# Rezoning Transportation Analysis

Petition Number: 2021-163

Date	Description
08-26-21	First Review (LH)

4. **6<sup>th</sup> Street Cross-Section:**
  - a. **New Cross-Section:** Include a second cross-section that shows a consistent 10' cycle track width and 11' travel lanes.

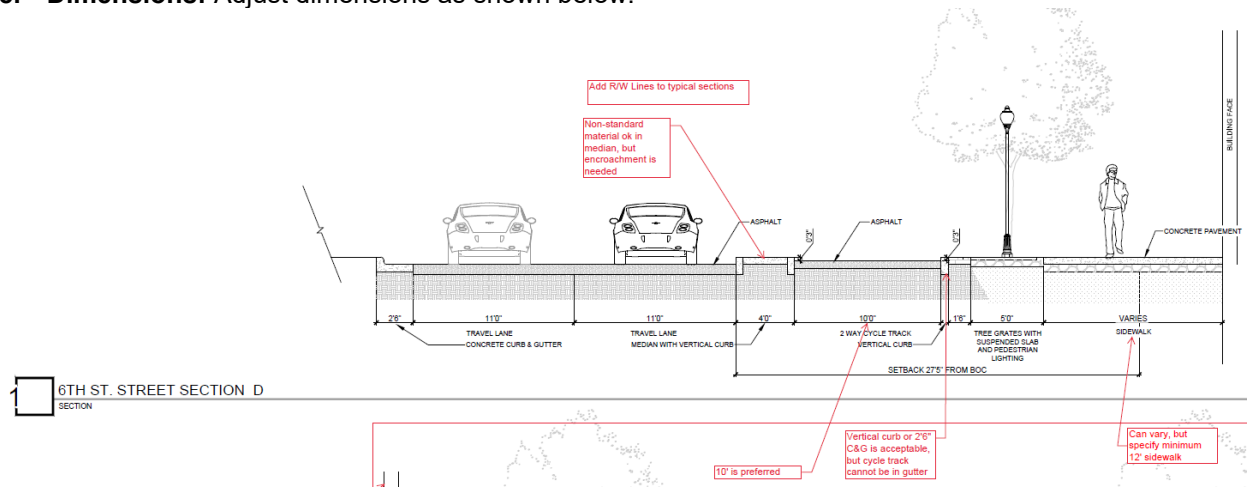
- b. **Right of Way:** Show right of way line on cross-section and ensure building face is outside of right of way.
  - c. **Pedestrian Pathway:** Update site plan and conditional notes to show minimum 12-foot sidewalk width.

- d. **Cycle Track:** Update site plan and conditional notes to show the correct and varied dimensions, as shown below. Add a conditional note that vertical curb and curb and gutter are both acceptable adjacent to the cycle track, but the gutter width cannot be used to account for the 10' cycle track width. Add a conditional note that nonstandard material is allowed in median between cycle track and vehicle travel lanes, but an encroachment permit will be required. Additionally, provide a conditional note that specifies the commitment of constructing the cycle track on 6<sup>th</sup> Street.

- e. **Dimensions:** Adjust dimensions as shown below:

5. **7th Street Cross-Section:**

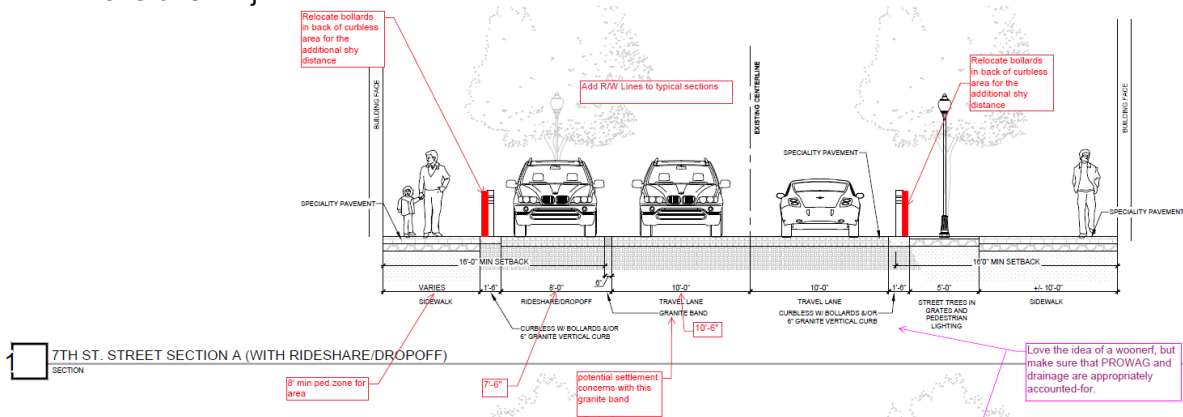
- Travel Lanes:** 10-foot travel lanes are not suitable for shuttles that would frequent the hotel or a CATS bus if 7th Street was used as a detour. Update travel lane adjacent to hotel to 10 foot, 6 inches minimum width. If using vertical curb, adjust for 11-foot travel lanes.

- Curbless Street w/Bollards:** Add a conditional note that states to confirm that PROWAG and drainage adjustments are accounted for during permitting. Place bollards as far away from travel lane as possible within the 1 foot, 6-inch flush granite curb. Show limits of bollards on site plan.

- Granite Band (proposed setback):** Potential settlement concerns with granite band separating travel area and rideshare/dropoff. Specify concrete base below granite, travel lane and paver sections to mitigate differential settlement.

- Right of Way:** Show right of way line on cross-section and ensure building face is outside of right of way
- Pedestrian Pathway:** Update site plan and conditional notes to show minimum 8-foot sidewalk width.

- Dimensions:** Adjust dimensions as shown below:
